DESIGN EXCELLENCE COMPETITION JURY REPORT

City of Parramatta

Phase 2 Competition for Architectural Design
Block H, Precinct B, Wentworth Point
21 November, 2019

Image: FJMT response to Jury revised 54k and 85k tower forms

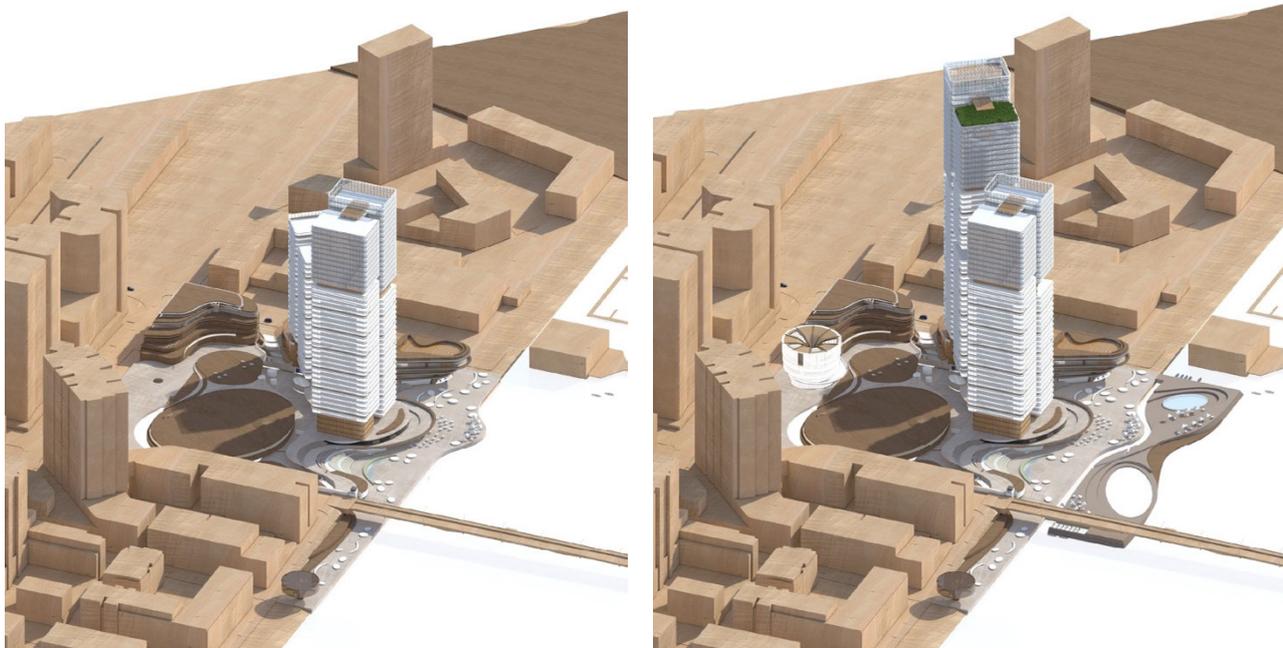
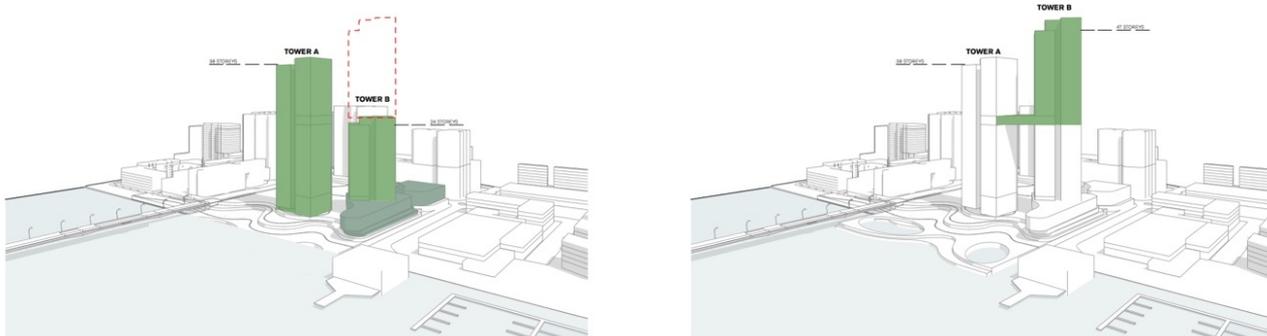
In responding to the Jury's preliminary comments, the design of the towers has been revised with altered orientations and approaches to articulation to reduce the perception of overall mass as well as introducing vehicle access into the park to the towers and replanning the foreshore building lines.

- Tower - location and orientation – The Jury are supportive of the approach to tower placement that ensures view sharing to adjacent developments is respected. The revised approach to tower rotation/orientation is also supported.

- Tower Façade – The revised façade treatments submitted as part of the response to Jury comments is strongly supported by the Jury, and should be retained at DA stage. This includes the provision of 500mm deep horizontal shading at various heights and increased solid spandrels.

Draft plan extract showing revised low level floor plates with improved ADG compliance (FJMT)

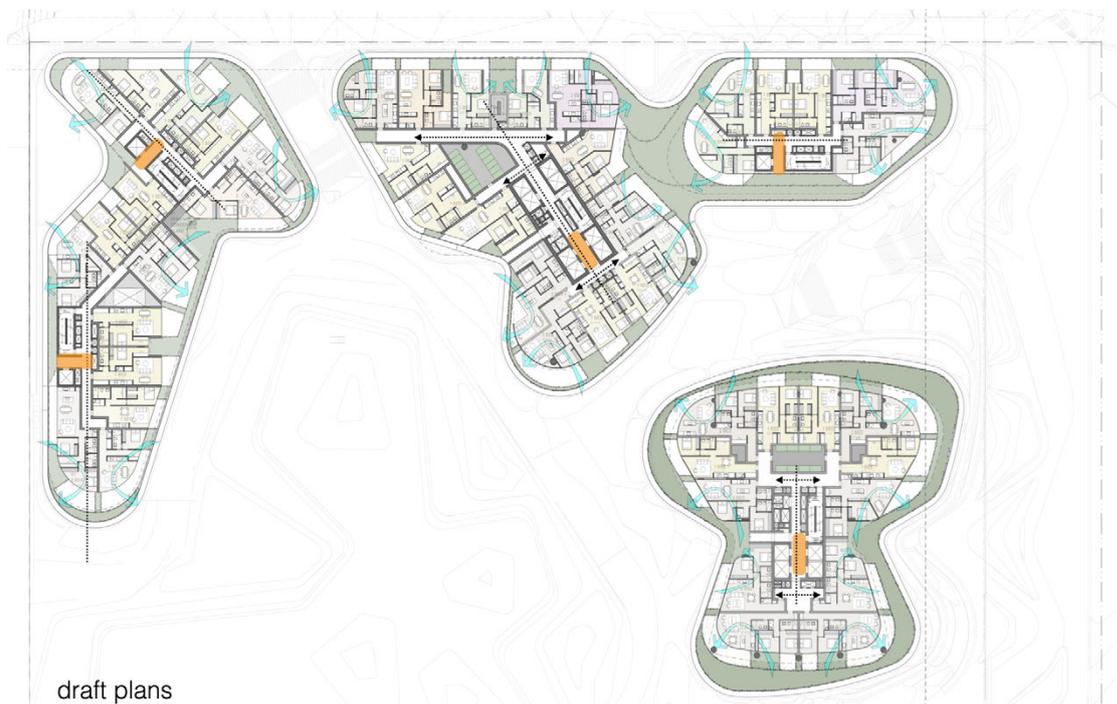
- The Jury are concerned that some key requirements of the ADG are not being achieved – including solar access and natural cross ventilation.
- In order to achieve Design Excellence, the Jury require that full compliance with the ADG is achieved. This requirement is considered acceptable based on the unconstrained size of this site, and the fact the design has been the product of a Design Excellence Master Plan Competition.

- The Jury requested that Council's independent ESD advisor review and comment on the draft submission.
- The key items that require design development are:
 - Natural Cross Ventilation remains unresolved and it is not clear how the ADG requirements will be met,
 - Adequate ventilation of enclosed balconies, and
 - Significantly challenged in achieving solar access compliance, particularly Tower A.

- Minimum ADG solar access and natural cross ventilation are achieved in the refined schemes, which are anticipated to achieve full Guide compliance.
- A more regular, “calmer” podium, has been reintroduced for a better urban outcome on Burroway Road and has been broken into three separate buildings to improve ADG environmental and amenity performance.
- A more measured exuberance is reflected in the schemes. The achievement of amenity, privacy, solar access and ADG compliance aspects of the “butterfly form” tower floorplates have been thoroughly considered and demonstrated in the revised schemes.

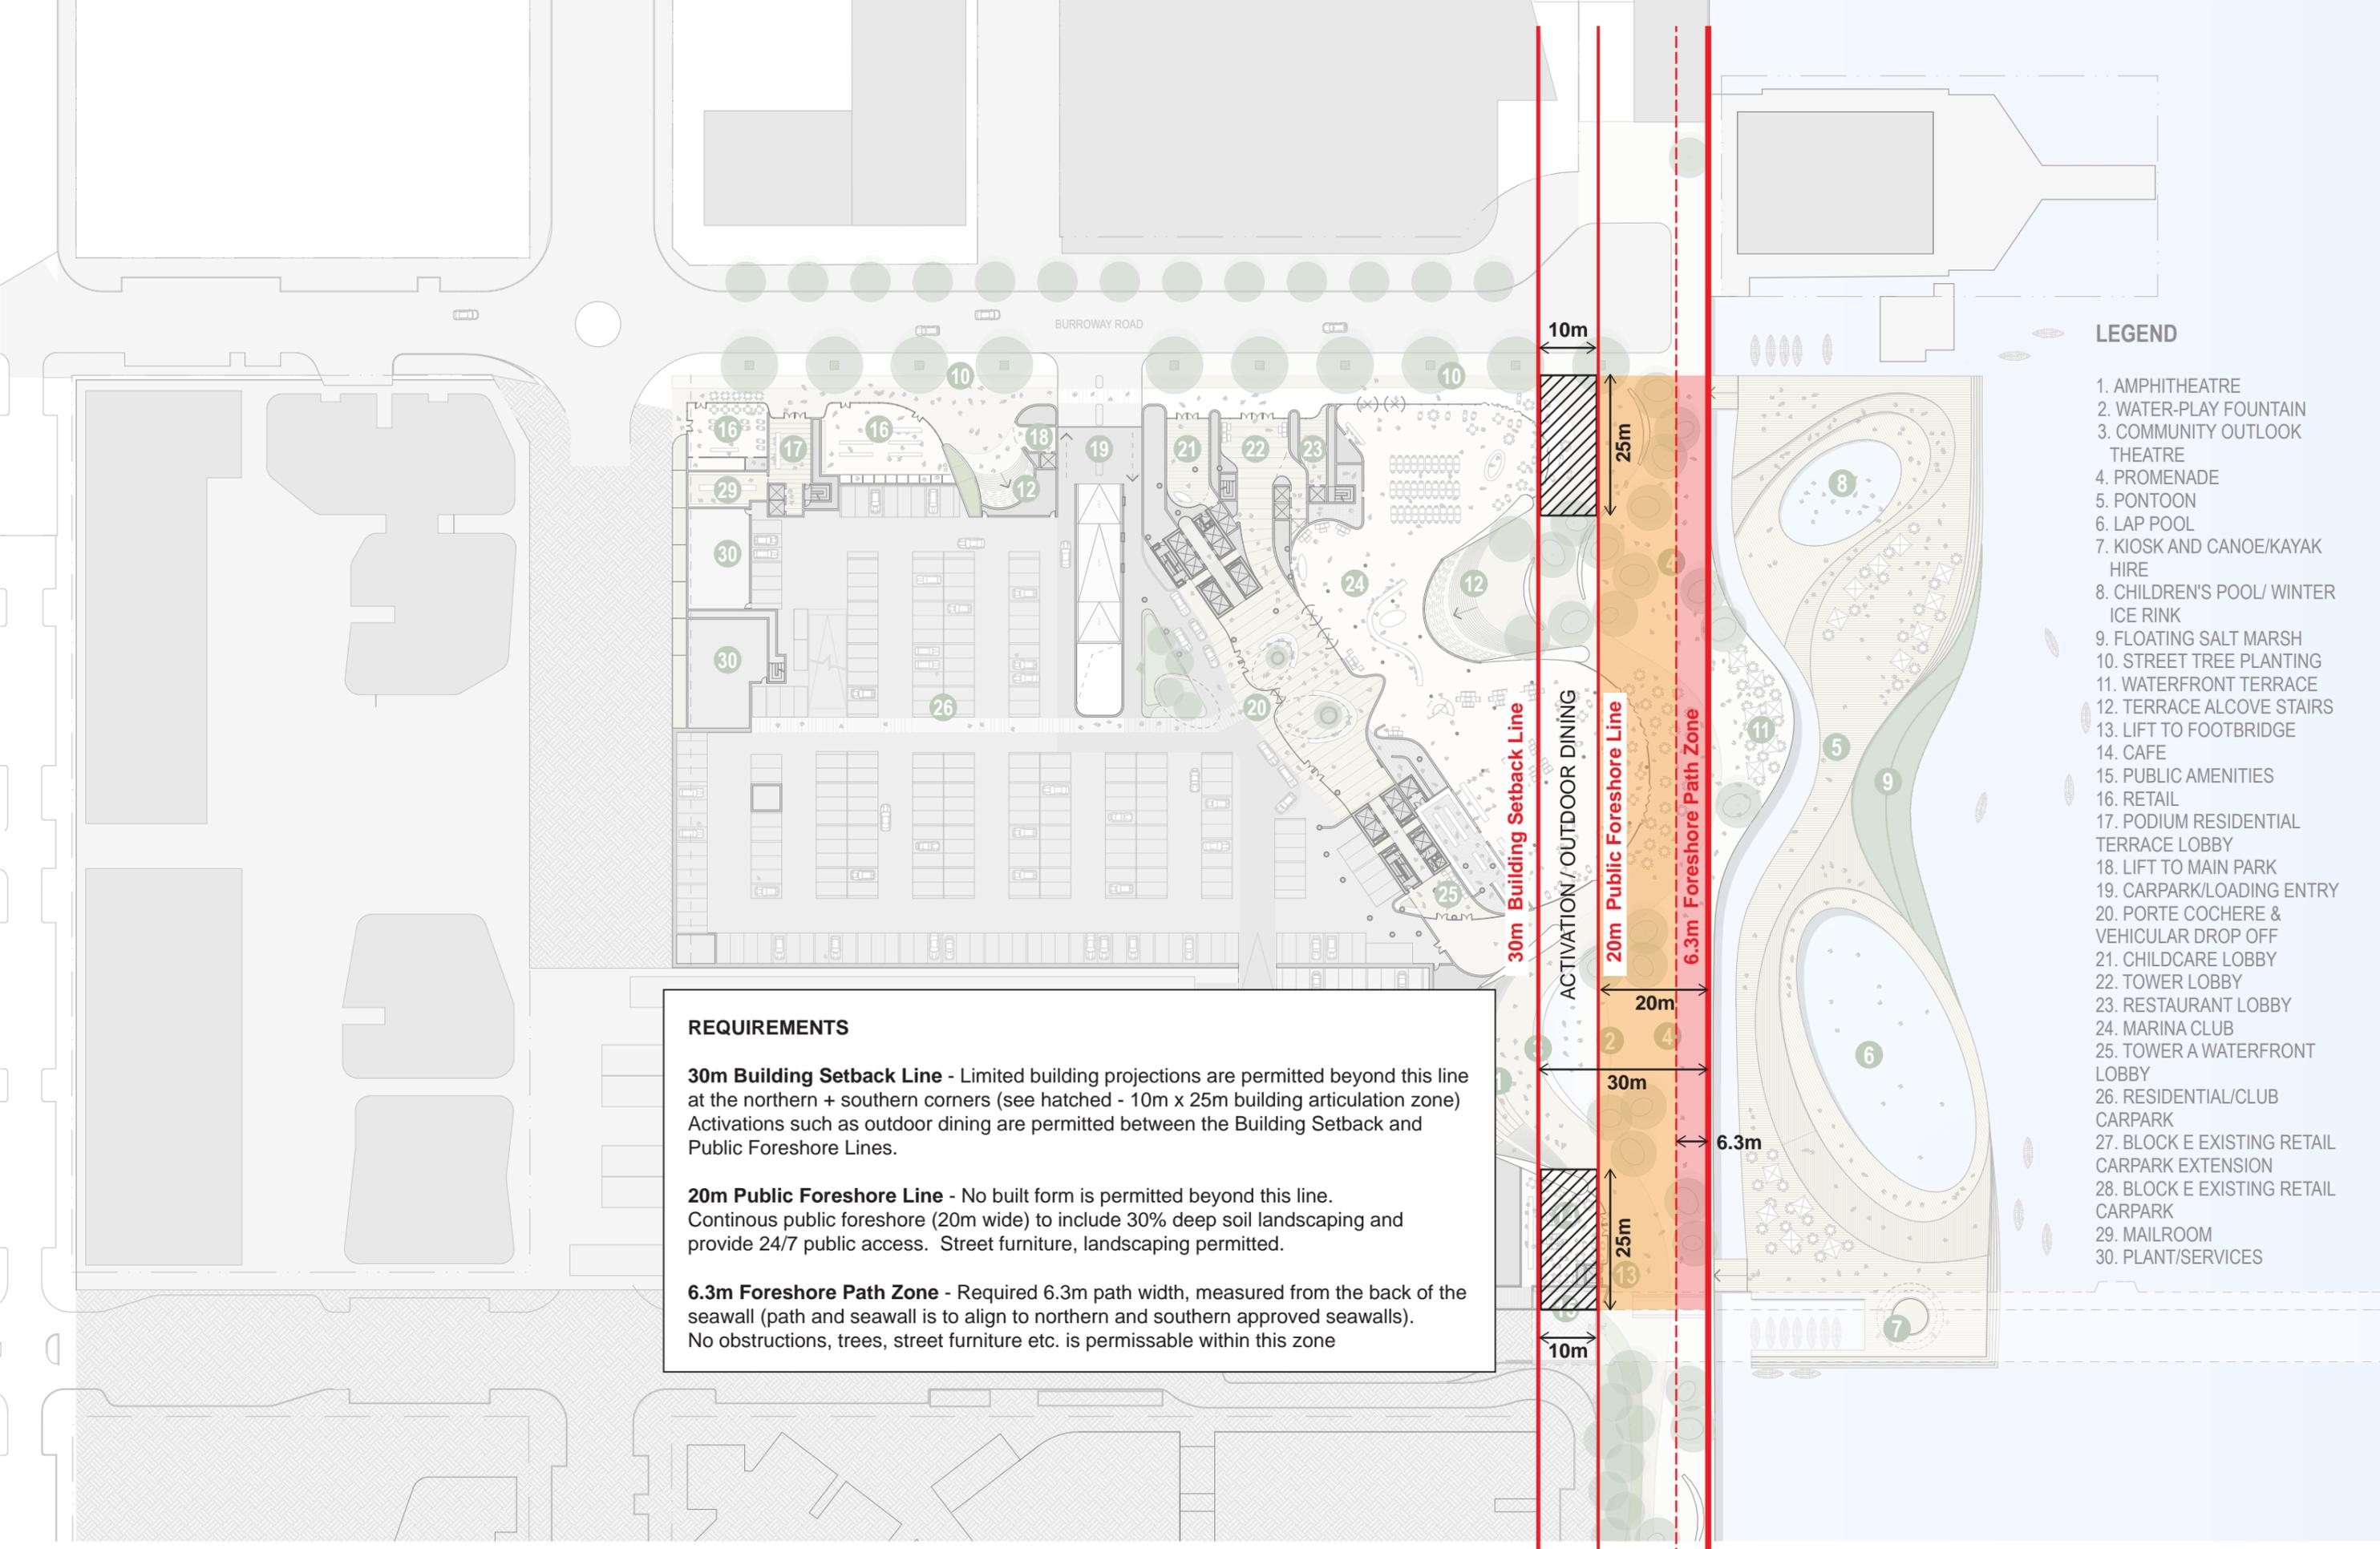
- Council planning officers have notified the Jury that the submitted design does not match with the design intent of the foreshore promenade.
- The Jury have requested that Council provide the design team with an annotated drawing (see attached) that outlines the planning requirements of the Foreshore Promenade – see attached.
- The design team are requested to recalibrate the design of the promenade so that it responds to Councils requirements, in particular, the control that does not permit built form to encroach beyond the 20m Public Foreshore Line.

20m Public Foreshore Line - No built form is permitted beyond this line. Continuous public foreshore (20m wide) to include 30% deep soil landscaping and provide 24/7 public access. Street furniture, landscaping permitted.

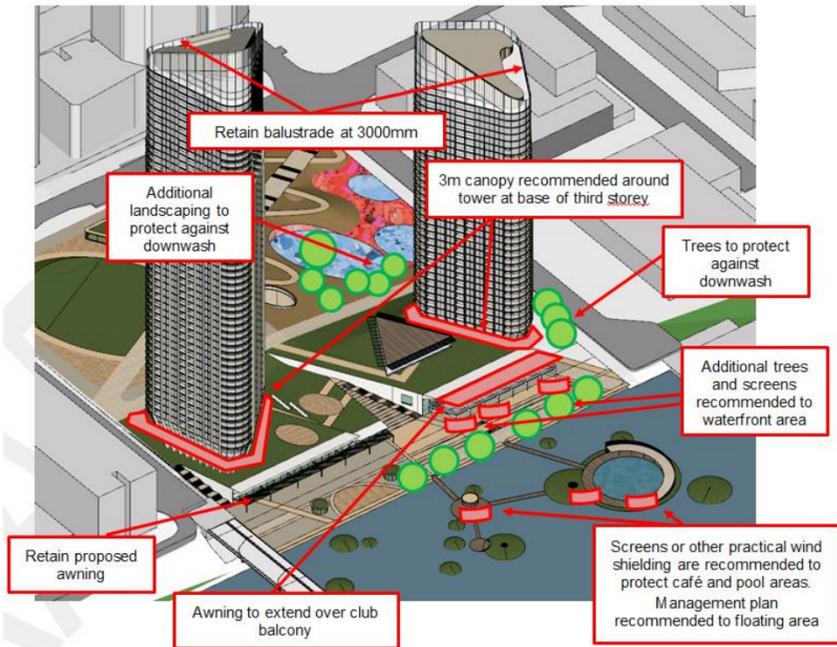
Waterfront Promenade: Landscaping and screens are recommended to protect seating and standing areas.

Floating Area: Screens or practical wind shielding is recommended to the area. A management plan regarding adverse winds and use of the public space is recommended to be applied to the floating area.

Club Balcony: Awning is recommended to be extended to protect seating and standing areas

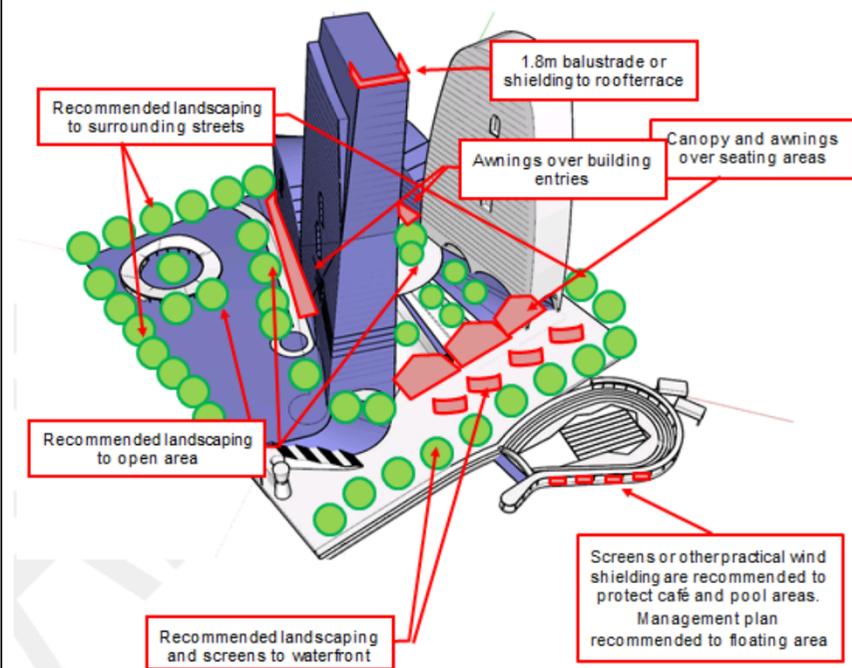
Floating Pool and Beach Area: Screens or practical wind shielding is recommended to the area. A management plan regarding adverse winds and use of the public space is recommended to be applied to the floating area.

Retail and Building Entries: Additional landscaping is recommended. Further awnings or canopies are recommended above building entries.

Open Park: Additional landscaping is recommended.

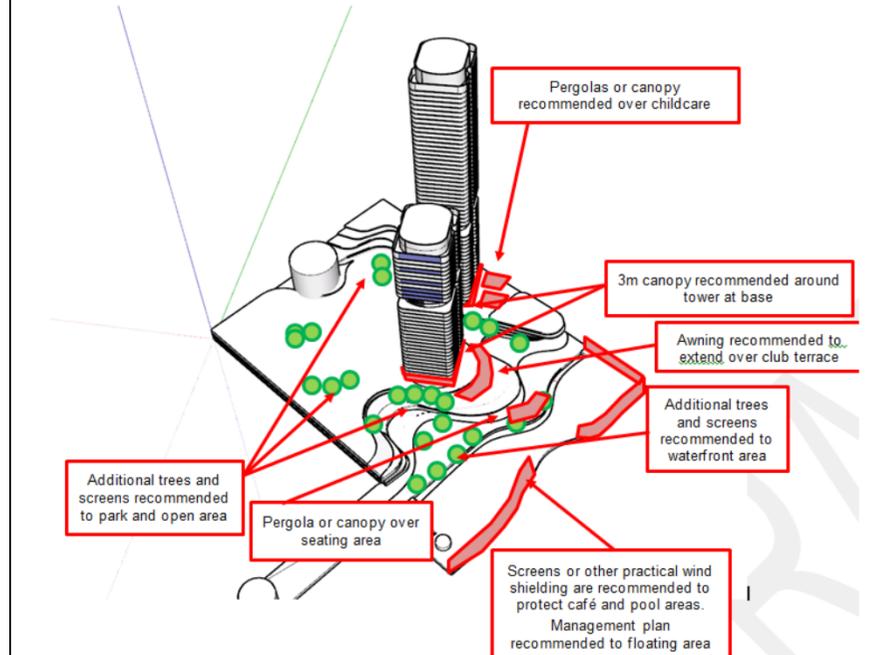
Floating Area: Screens or practical wind shielding is recommended to the area. A management plan regarding adverse winds and use of the public space is recommended to be applied to the floating area.

Club Terrace: Extend awning above or incorporate pergolas/ canopy to protect seating areas.

Tower Entries: A 3m canopy is Recommended to the surrounds of both towers to be applied as low as practically feasible. Alternatives to this could be assessed through quantitative testing during DA stage.
